Product Change Notification

Product Change Notification: PCN-23-175959

DEUTSCH DTM/DTMH Series Backshell Adapters.

Before

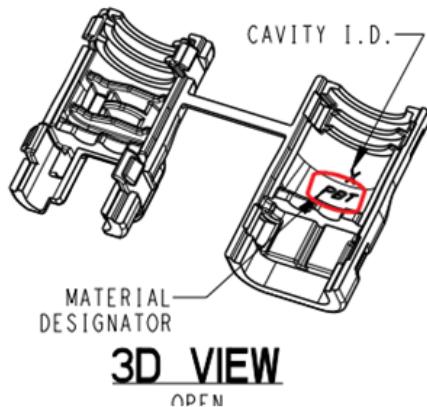
The Industrial and Commercial Transportation business unit of TE Connectivity is making a drawing change for the product drawing(s) listed below.

Dear Customer, we hereby inform you of this drawing change. This modification is necessary to reflect the change communicated previously through PCN-23-174160. The change does not impact performance. IMPORTANT: The current and previous revisions of these parts can be used interchangeably in the field. The change(s) are being phased in gradually and previous revision can remain stocked until use. Shipments of both configurations may be mixed.
